RS-14-033

Braidwood Station, Units 1 and 2
Facility Operating License Nos. NPF-72 and NPF-77
NRC Docket Nos. STN 50-456 and STN 50-457

Byron Station, Units 1 and 2
Facility Operating License Nos. NPF-37 and NPF-66
NRC Docket Nos. STN 50-454 and STN 50-455

Subject: Response to NRC Requests for Additional Information for the Severe Accident Mitigation Alternatives Review, dated January 6, 2014, related to the Braidwood Station, Units 1 and 2 and Byron Station, Units 1 and 2 License Renewal Application

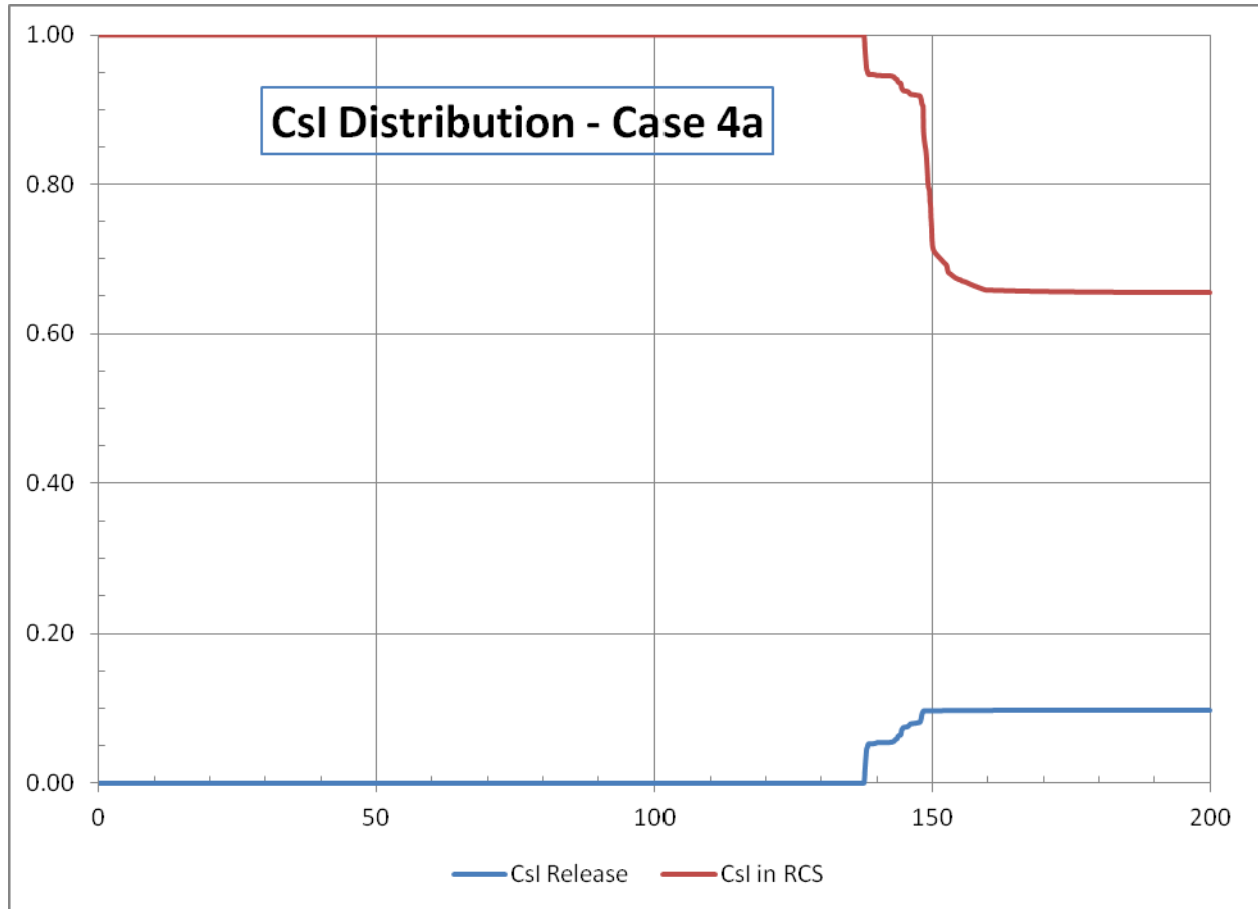
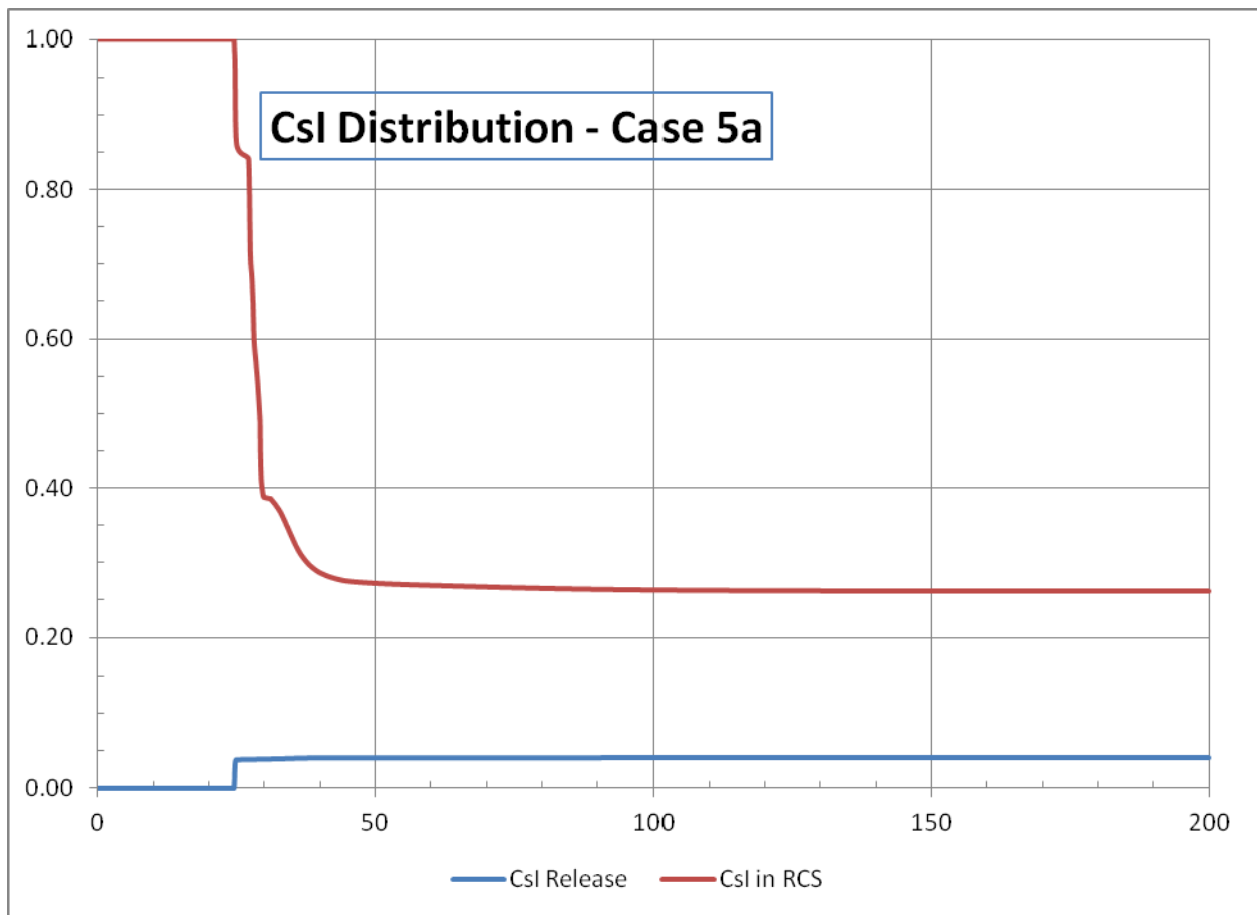
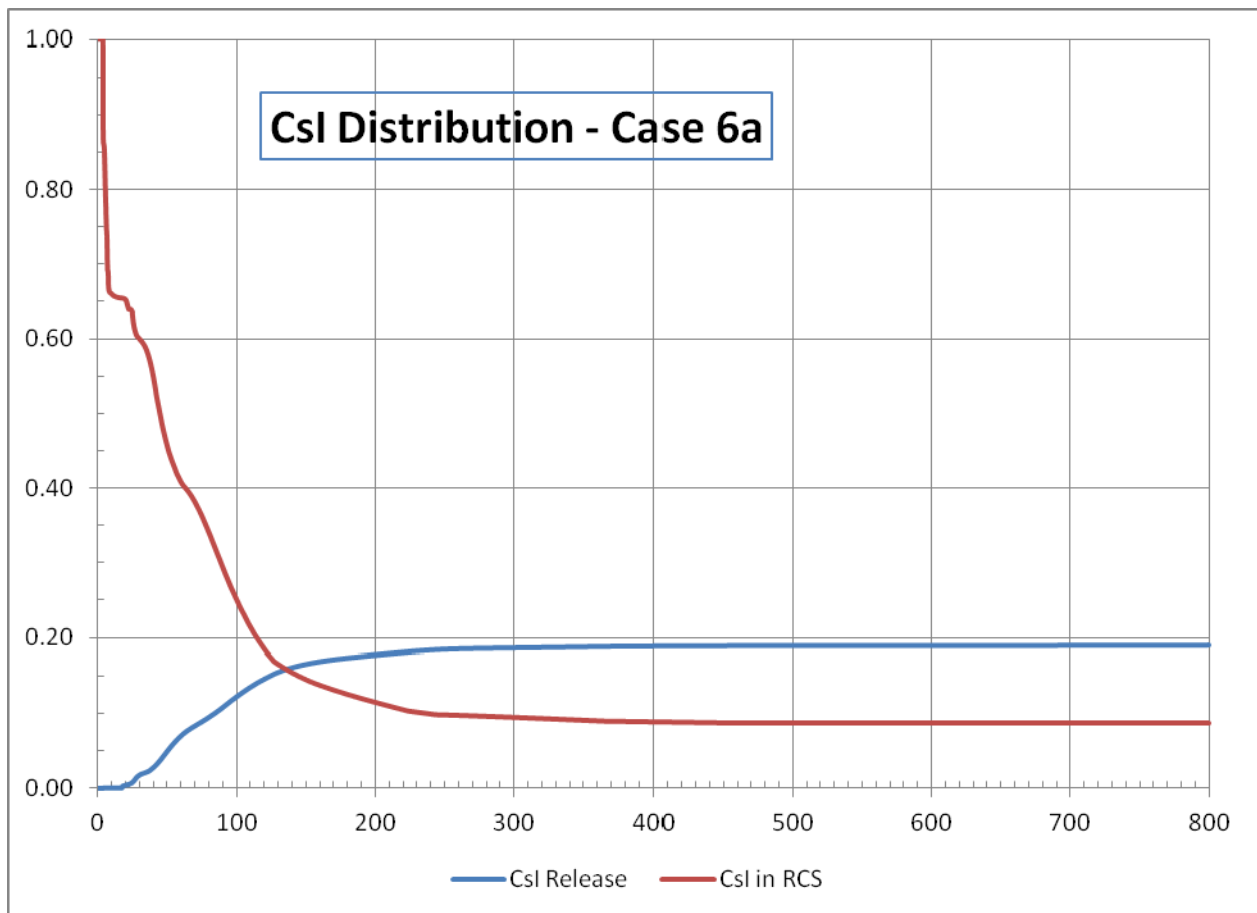
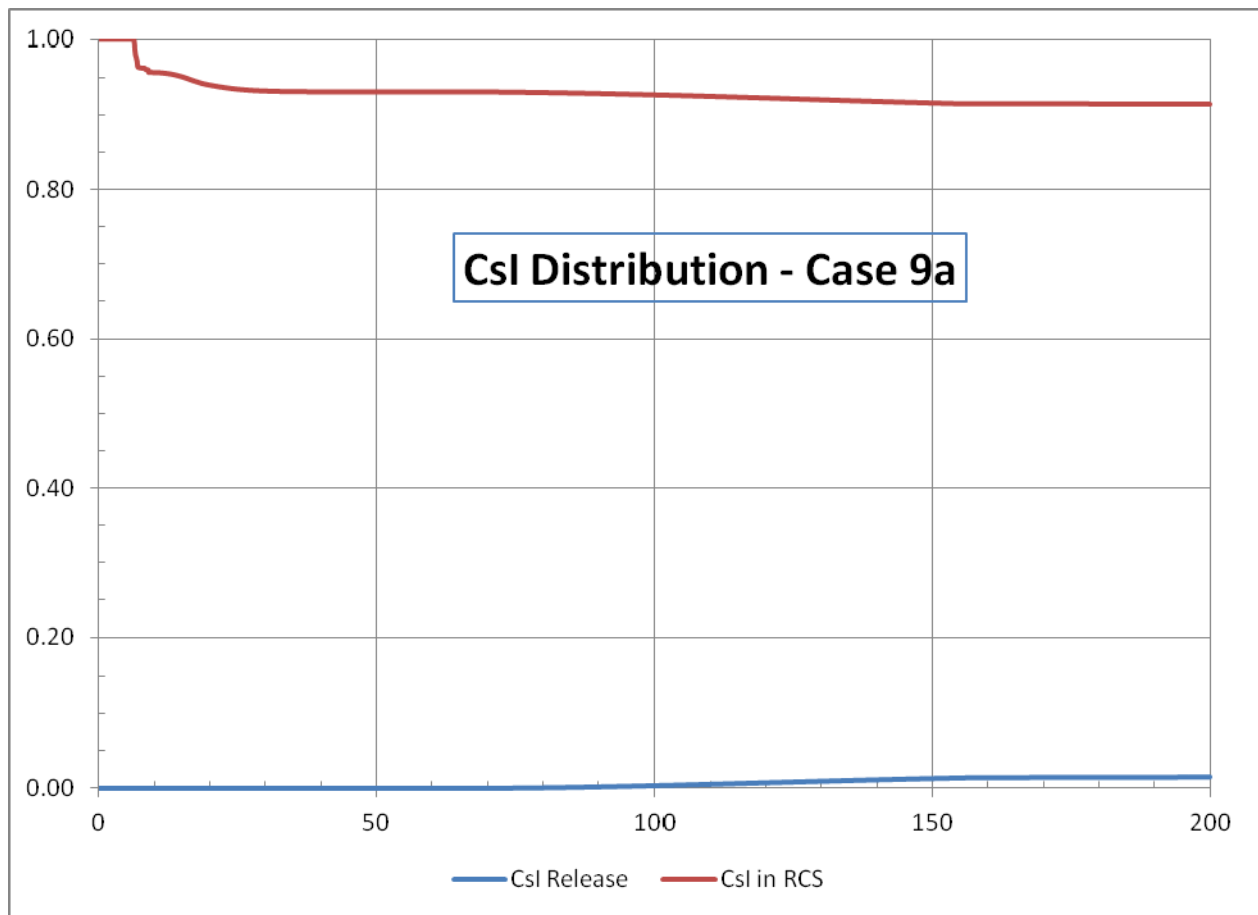
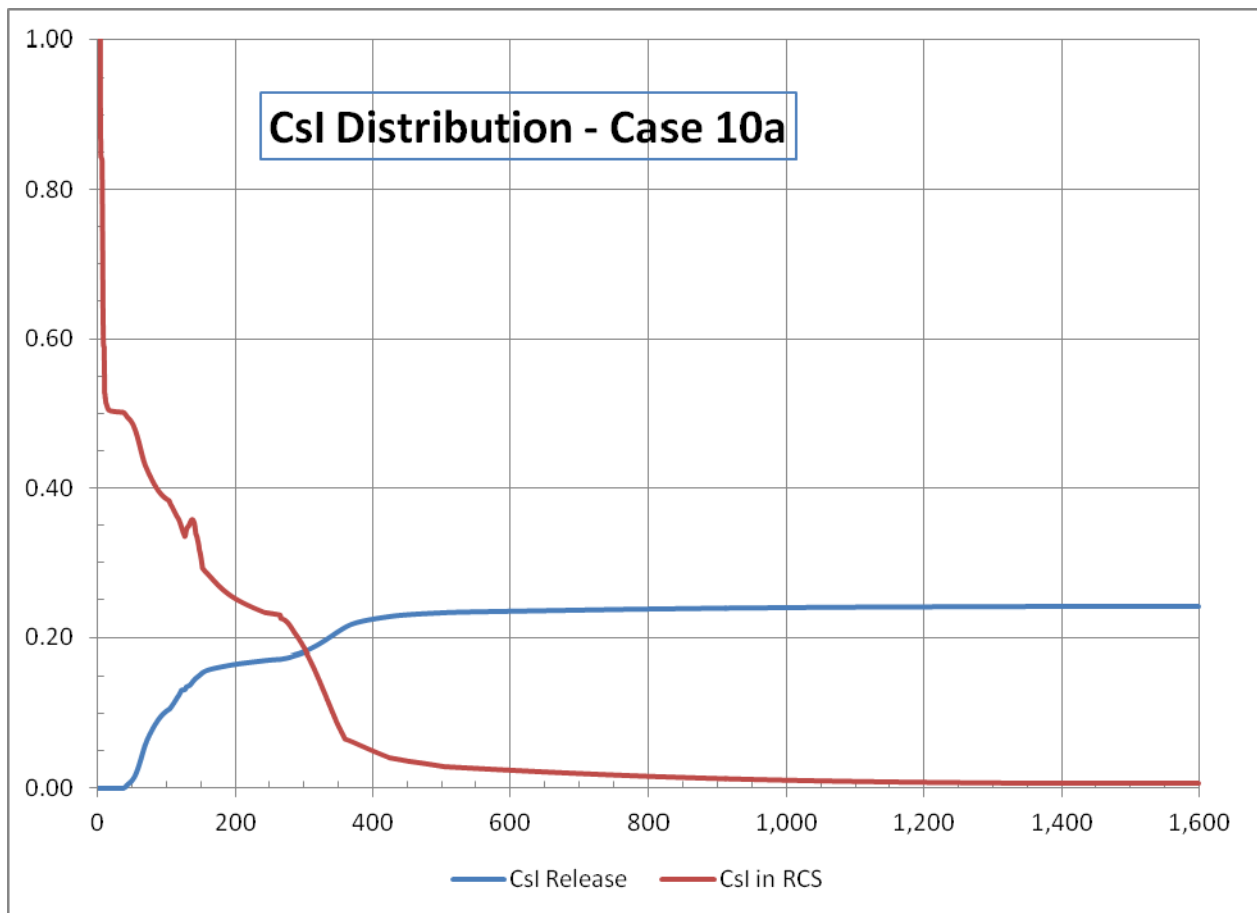
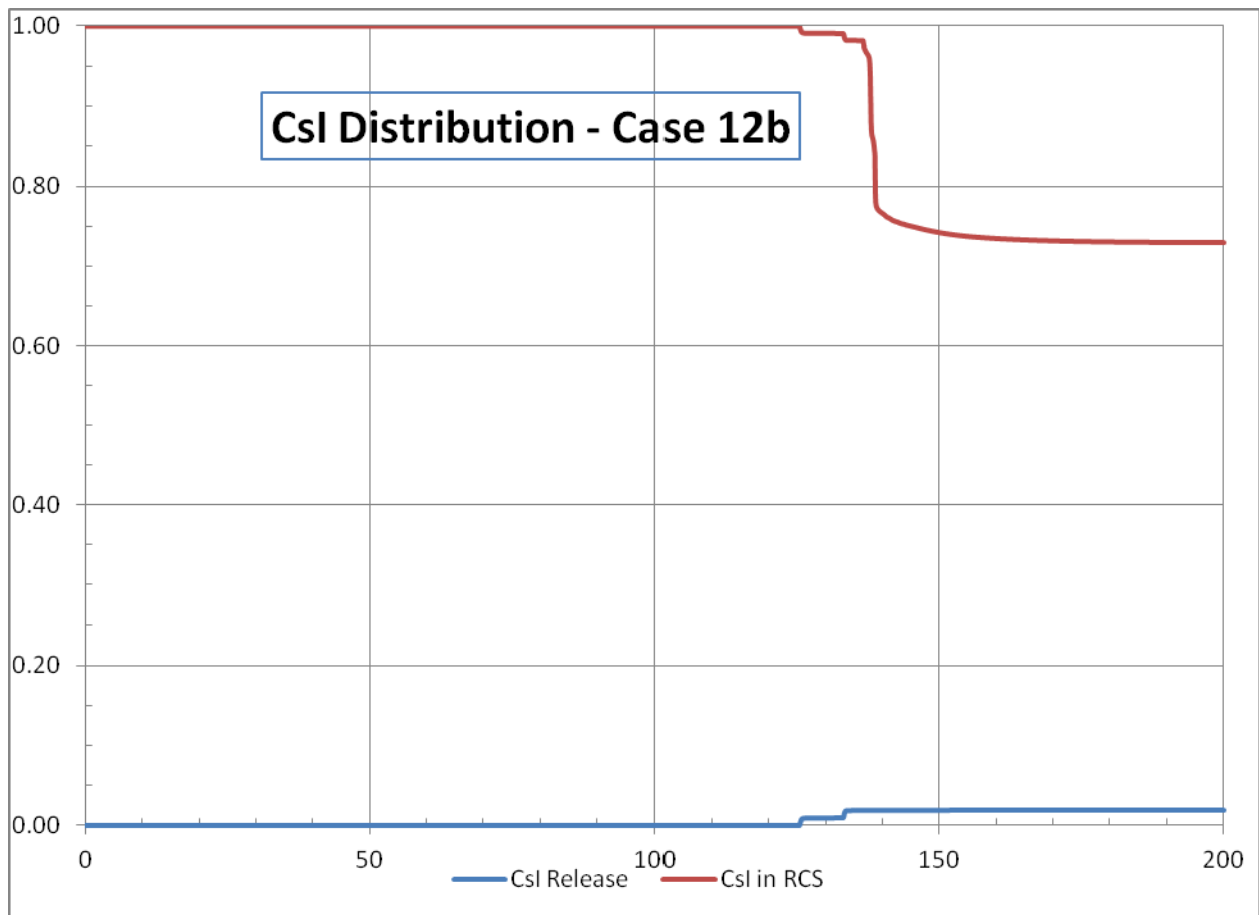
Table F.2-7 provides the modular accident analysis program (MAAP) results for several cases for 200, 800 and 1600 hour runs. Section F.3.5 and Table F.3-8 identify that the "MAAP cases were run to achieve a plateau of the release fractions, with primary attention paid to CsI and [cesium hydroxide] CsOH release fractions." Provide additional discussions concerning the CsI and CsOH release fraction contribution occurring for Cases 4a, 5a, 6a, 9a, 10a and 12b (e.g. what were the relative increase in fractions for extending the MAAP cases to such long time frames; what was the fundamental cause of the continuing release, etc.)

Additional information is provided in the attached figures showing the CsI release fraction along with the fraction of CsI contained within the RCS boundary. The run time for various MAAP calculations is established based on:

1. The timing for the onset of core damage. Sufficient time after core damage is selected to represent the initial release from the core and subsequent release from the containment.
2. The timing for either containment failure or containment bypass. The run time is established based on the initial release from the containment with sufficient time to obtain a stable release.
3. Fission products can be initially deposited within the RCS, particularly on the steam generator tubes. After the steam generator dries out and the tube temperature increases, the deposited fission products can revaporize and become available for release late in the event.

The attached plots show the release from the containment along with the amount of CsI within the RCS. As a result of core heatup, the amount of CsI in the RCS can be seen to decrease. Even though the majority of the CsI is released from the core, it may remain within the RCS as deposited mass on the steam generator tubes. Later in the scenario, the CsI fraction within the RCS may be seen to continue to decrease as a result of heatup and revaporization.

The run times were selected to make sure to capture this phenomenon and in many cases a stable total release from the containment is achieved well before the end of the run. As an example, the figure for Case 5a would indicate that a run time of about 50 hours would have been sufficient. On the other hand, Case 10a shows that the release does not reach a stable value until about 600 hours. Where CsI is used here to demonstrate the method for establishing the run time, CsOH releases would yield a similar conclusion.

Figure 4.I-1

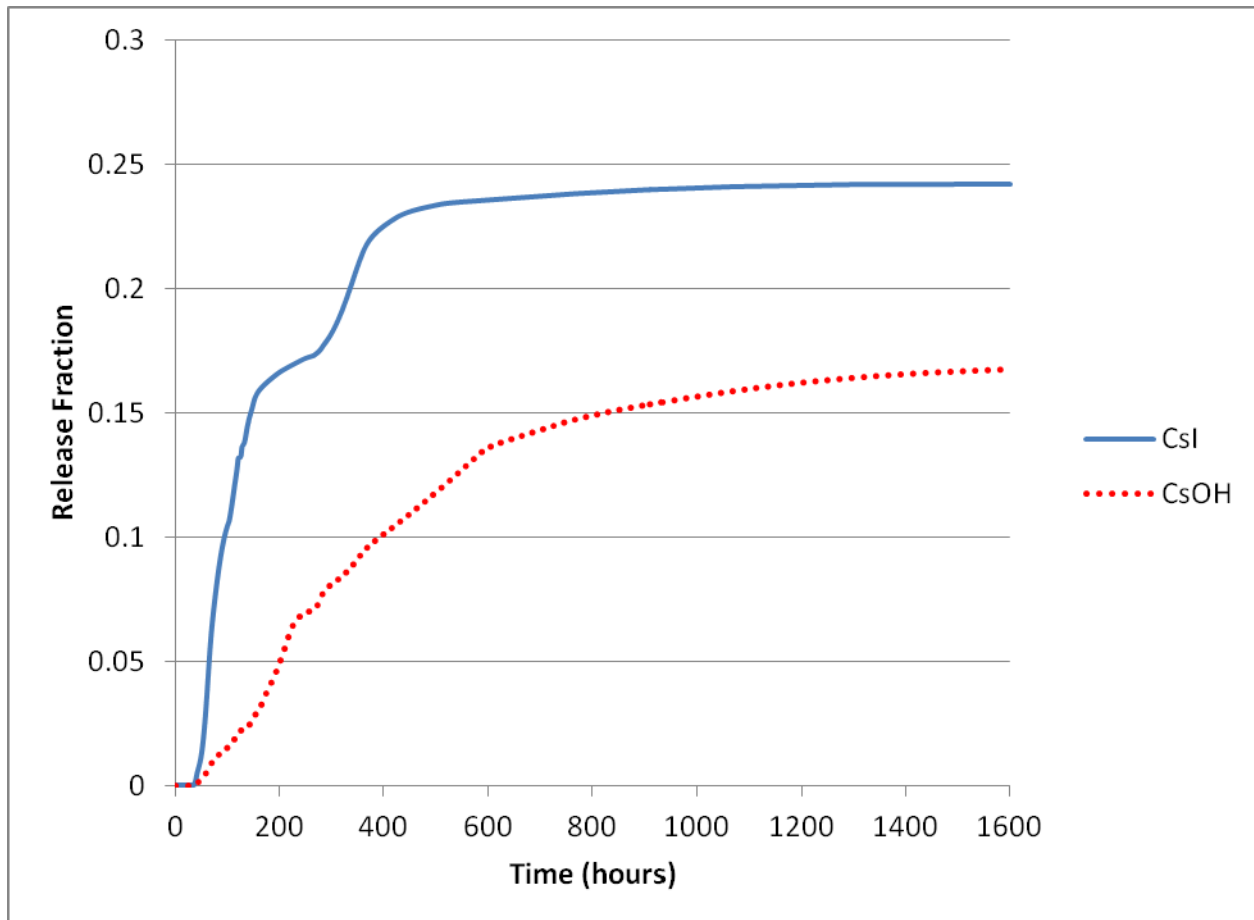
For both Byron and Braidwood, provide a discussion of the major contributors/factors that contribute to the magnitude of the Byron and Braidwood MACR and provide a qualitative assessment of the relative effect and the realism or conservatism of these factors.

- The LATE-CHR-NOAFW source term release fraction was developed as part of the Level 2 model update to support the SAMA analysis. One of the goals of the source term analysis was to ensure the run times for the scenarios were long enough to adequately characterize the radionuclide release fractions. The MAAP case for this release was run out to an extraordinarily long time of 1600 hours (i.e., more than 60 days following core damage) in order to capture the CsI and CsOH release that continued to trend upward with time (see Figure 4.I-1). The CsOH release magnitude is a primary driver for long term dose and costs. Modeling the release over this long time period is considered conservative since off-site resources are expected to be available in this timeframe to mitigate the continued significant releases of CsOH. In addition, NUREG/CR-7110 indicates that only a small fraction of the Cs is in the form of CsI and that the dominant chemical form will be cesium molybdate with the remaining Cs in the form of CsOH. The Byron & Braidwood SAMA analyses assume that the dominant Cs chemical form is CsOH. Cesium molybdate has a very low vapor pressure and would therefore be expected to remain deposited on structures (e.g., the tubes in a steam generator) for a longer time relative to CsOH. Had the LATE-CHR-NOAFW MAAP run been terminated at an earlier time, such as 200 hours (similar to most of the other releases), the CsOH release would have been significantly lower. Thus, the long
